CITY OF ALBUQUERQUE

RE: **Oso Bio Syringe Line**
Grading Plan for Building Permit 4401 Alexander Blvd
Engineer's Stamp Date 12/22/2017 Disapproved
Hydrology File: F16D003B1

**RE: Oso Bio Syringe Line
Grading Plan for Building Permit 4401 Alexander Blvd
Hydrology File: F16D003B1**

XREF FILE(S)
 DRAWING NUMBER
C1.3

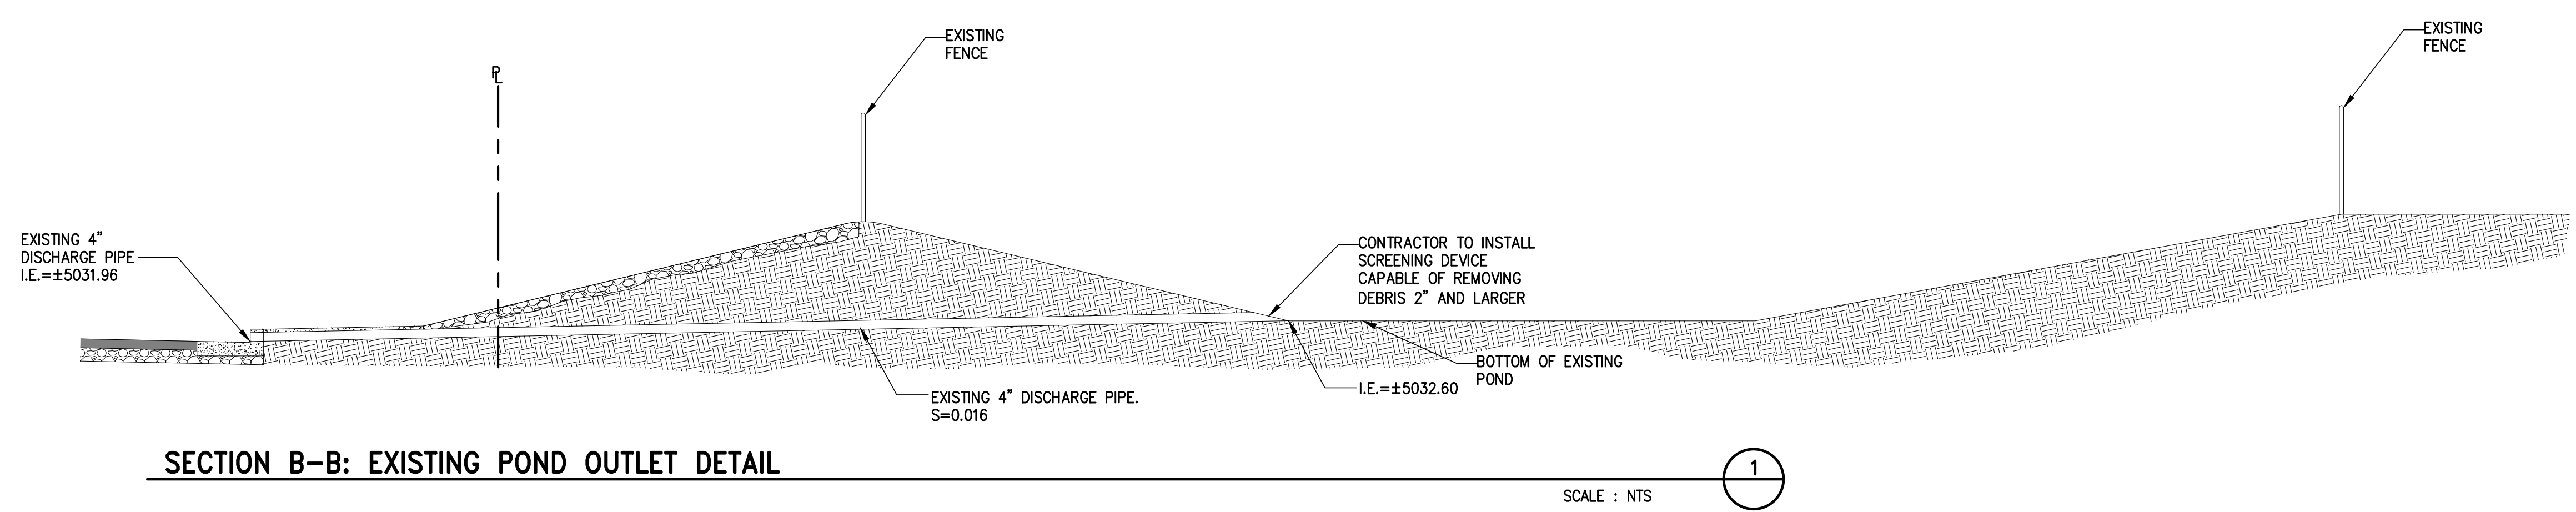
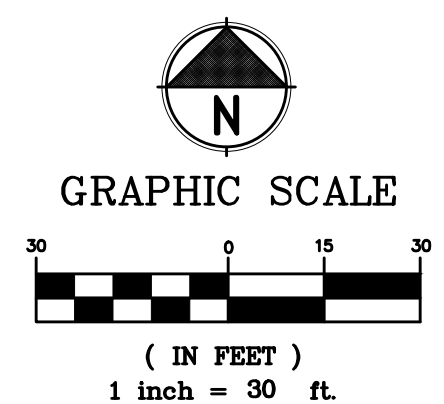
1. The existing pond does not have capacity for the 100 year flow and must be redesigned and reconstructed in accordance with the Drainage Master Plan for Sundt Industrial Park and the City of Albuquerque design guideline as contained in the Development Process Manual. If the pond outfall structure is redesigned to increase the peak flow rate from the pond and decrease the required volume, then the pond must be redesigned to provide retention of the First Flush volume (0.34" x The impervious area) for the portion of the site(s) draining to the pond. The new outlet structure may discharge at a higher rate so long as the total peak flow rate in the road at the northwest corner of the site does not exceed the allowable 32.35 cfs. The outlet structure must include a trash rack to prevent floatables from leaving the pond during high flows. Sheet C1.3 should be revised to show the details of the new design.

2. The existing pond topography is grossly inaccurate because it does not show the pond dam. Both existing and proposed topography must be shown for the pond, and the pond must be constructed to accommodate the new design volume(s).

4. A detail of the pond outlet structure is still needed on the plan.

An existing cross section detail has been drawn on the storm drain plan to show the existing pond and the 4" Ø discharge outlet. Based on the existing calculations and available information, DCI believes that the pond outlet structure is limited to a single 4" Ø pipe from the original pond design for the previous project "Albuquerque Ambulance, Tract A Block 5 of the Sundt Industrial Center" (F16/D3B1).
